Driveway Variances Staff Report and Recommendation

Community Development Department, Planning Division

FILE NUMBER(S): 311-19-000033-PLNG

PROPERTY LOCATION: 4115 24th Avenue

TURN OUT
YEW ST TRUCK TURNING
55' DRIVEWAY WIDTH

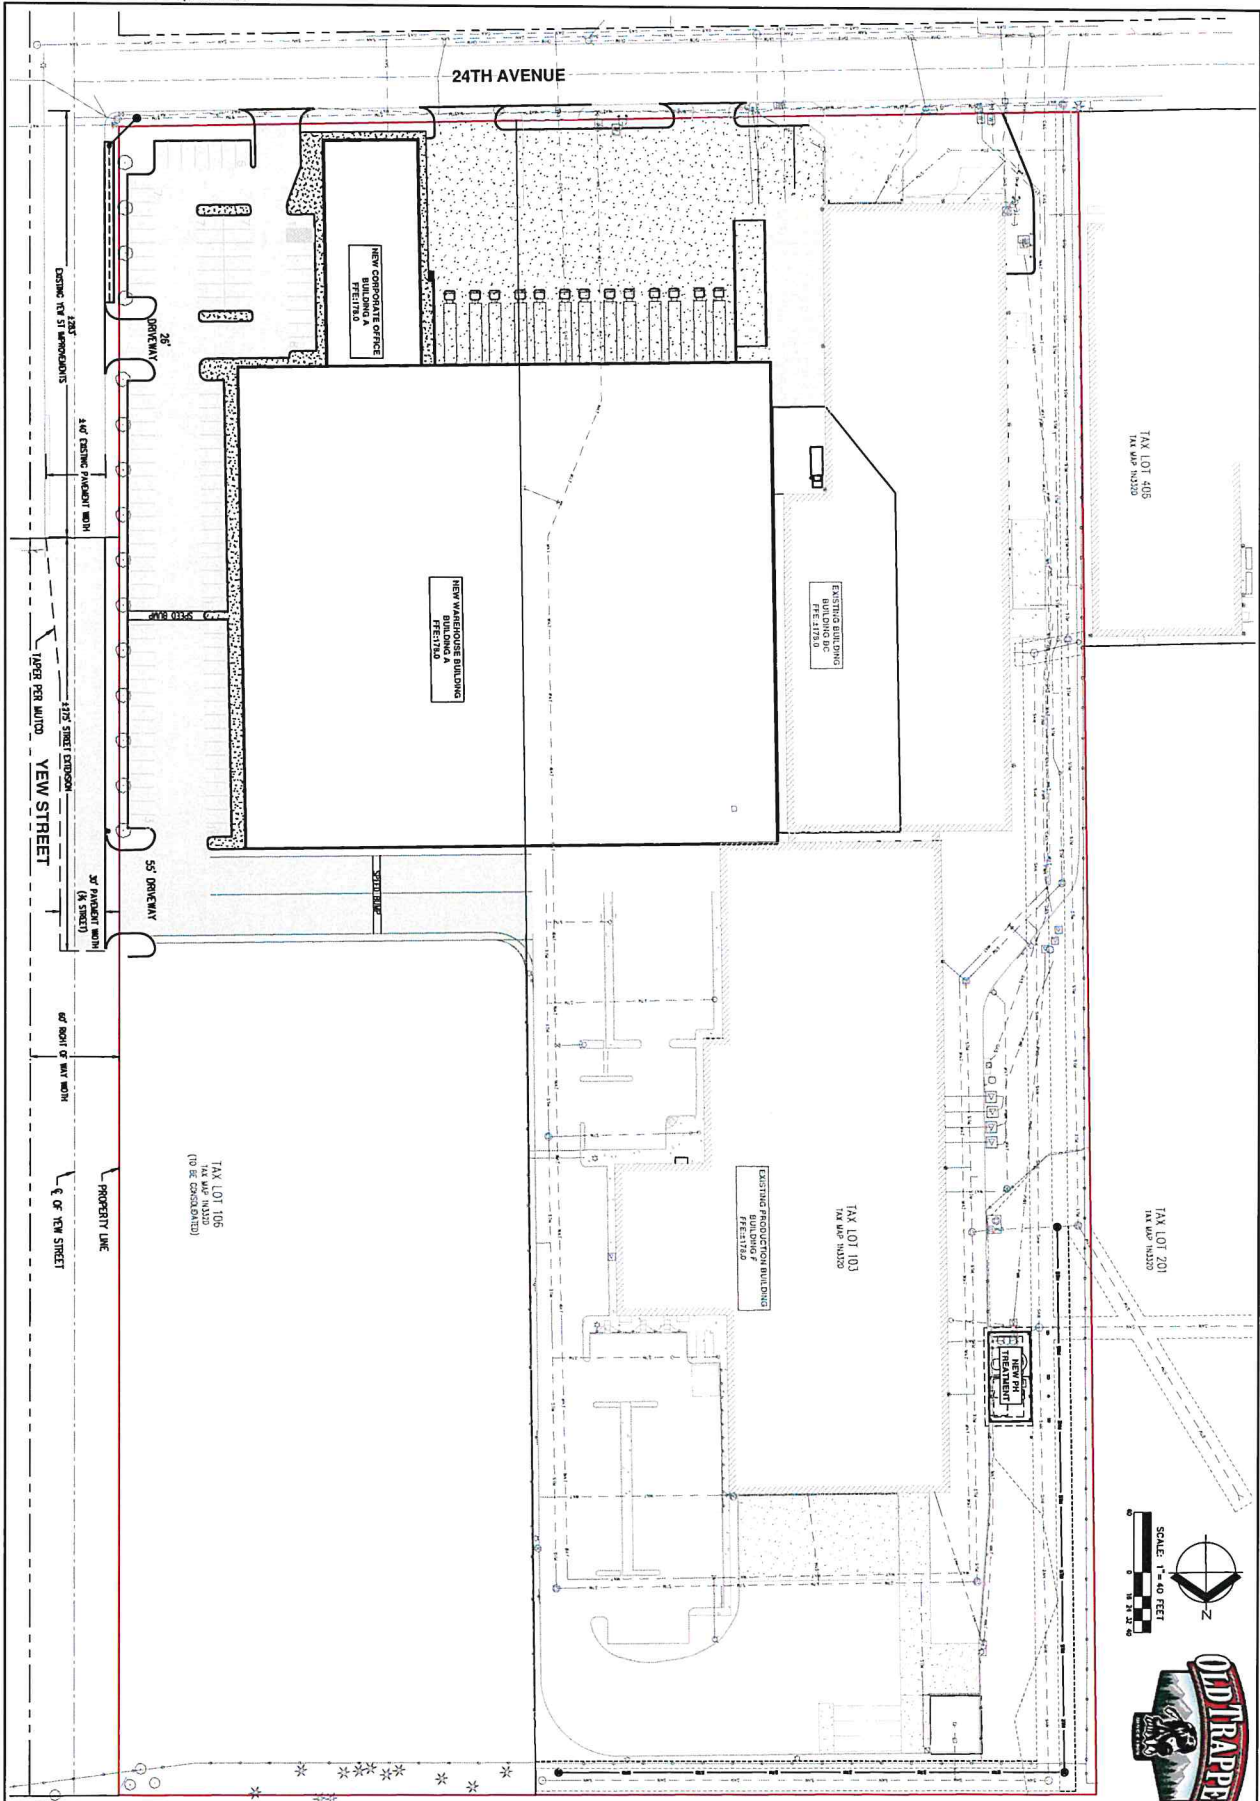
The interim, narrower-than-standard improvement to Yew Street is the reason behind the proposed 55-foot-wide driveway. Truck turning movements would be constrained due to the narrower street width. To ensure safe operations, the driveway is proposed to be commensurately wider. This additional width would no longer be necessary once Yew Street is fully improved. Staff has therefore included a proposed **condition** that this driveway be reduced in width to 40 feet when this segment of Yew Street is fully improved to City standards.

Finding: The interim, narrower-than-standard improvement to Yew Street is the reason behind the proposed 55-foot-wide driveway. Truck turning movements would be constrained due to the narrower street width. To ensure safe operations, the driveway is proposed to be commensurately wider. However, this additional width would no longer be necessary once Yew Street is fully improved. With the condition to reduce the driveway width to 40 feet when this segment of Yew Street is fully improved to City standards, this driveway would no longer be out of compliance with Development Code standards.

1. Narrow the width of the proposed east 24th Avenue driveway to 20 feet, to provide 100 feet of distance from the proposed center 24th Avenue driveway.
2. When Yew Street north of 24th Avenue is fully improved, the north driveway shall be reduced in width to not more than 40 feet.

Site Plan Detail

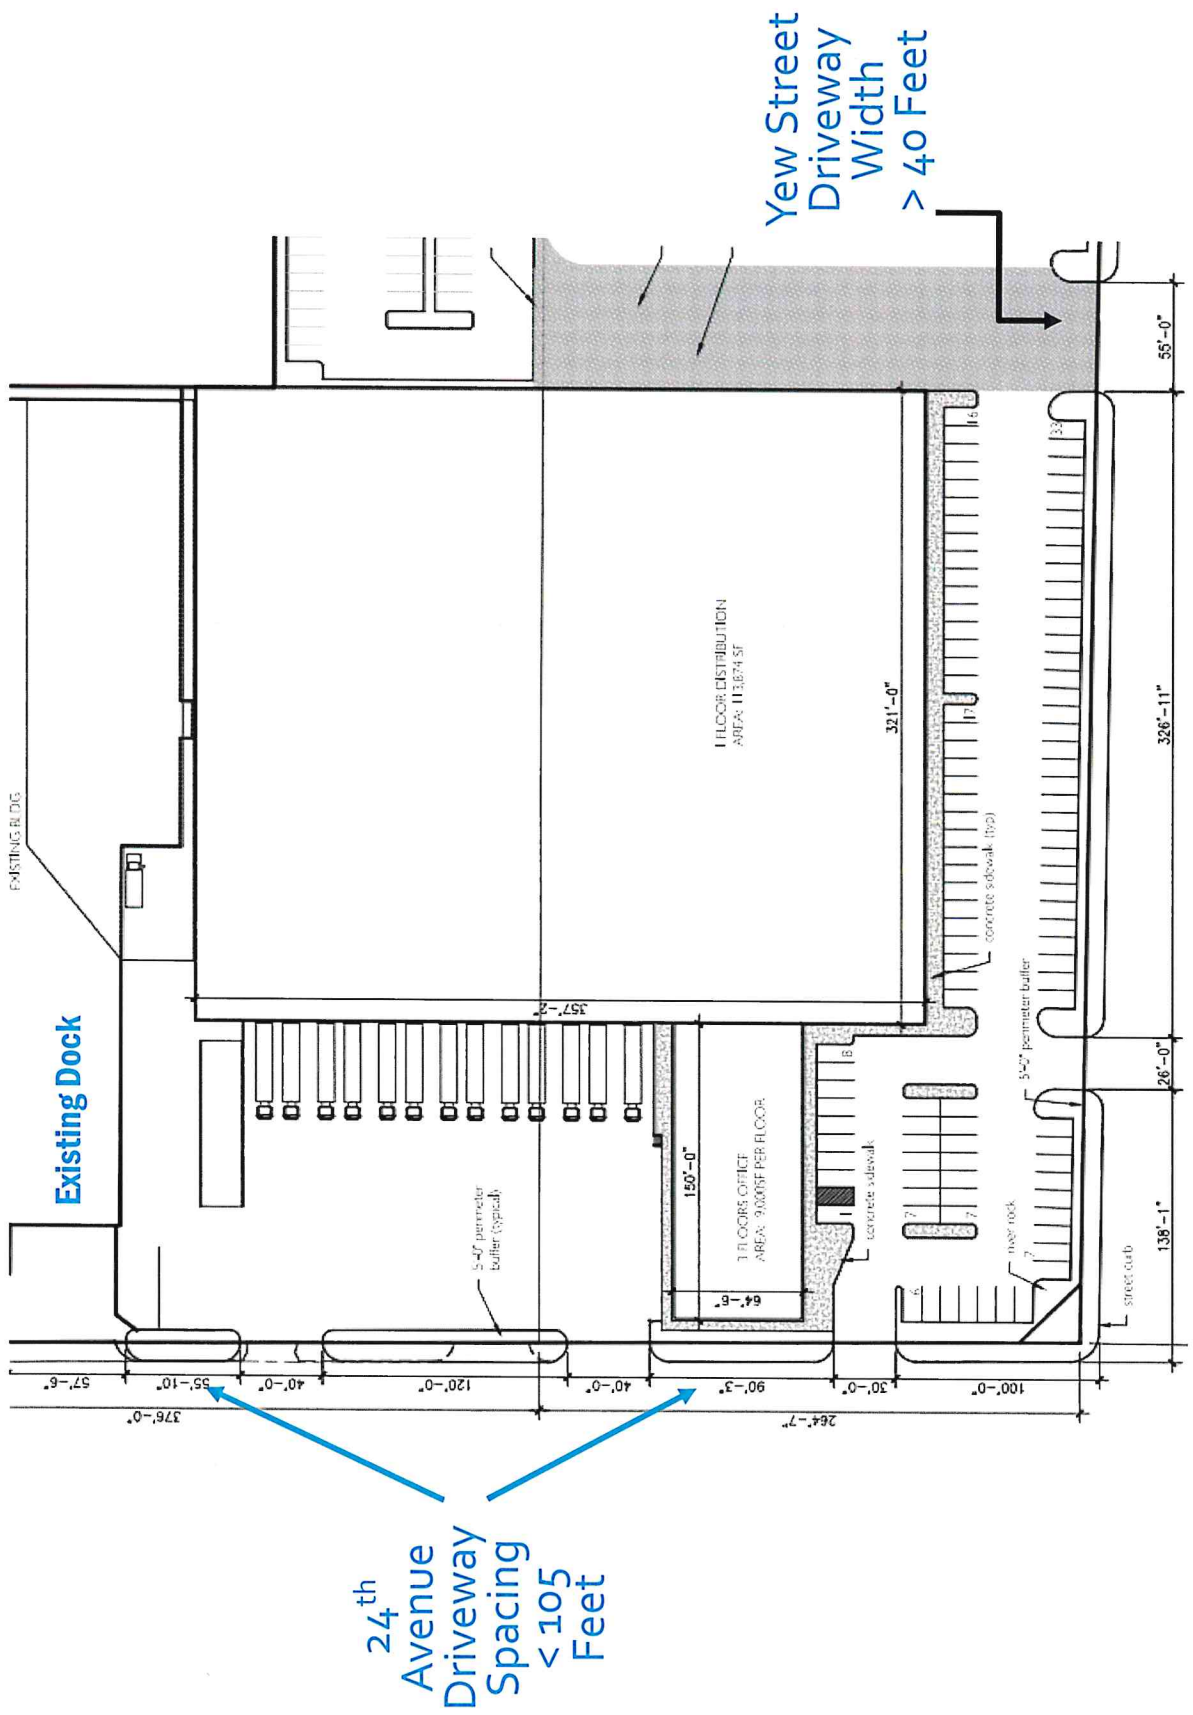
The new east driveway on 24th Avenue is proposed to be 30 feet wide. Staff has confirmed with the applicant's representative that this driveway – and the south Yew Street driveway – would serve only to provide access to the employee car park. Since these driveways would not be used for truck traffic, either or both of them could be as narrow as 20 feet and still allow for unrestricted, two-way access.

The new west driveway on 24th Avenue would be located about 56 feet from an existing driveway. This new driveway – along with a new center driveway – would serve the loading dock area exclusively. The locations of both driveways would allow free, unconstrained truck turning movements. Unlike the previous variance request, no backing movements directly from 24th Avenue would be required. While the driveways would be located closer than the Development Code stipulates, traffic movements on 24th Avenue would actually be better than with the original variance request, since trucks would not be backing into the site from the street.

The proposed distance between the center and east driveway would be about 90 feet. This could be increased to 100 feet if the east driveway was narrowed to 20 feet. Narrowing the driveway to 20 feet and thus increasing the distance between driveways to 100 feet would result in just the slightest of spacing variances (5 feet) for these driveways, with no loss of on-site functionality. Staff has therefore included a proposed **condition** to limit the 24th Avenue east driveway width to 20 feet.

1. Narrow the width of the east 24th Avenue driveway to 20 feet; and
2. When Yew Street is fully improved, the north driveway shall be reduced in width to not more than 40 feet.
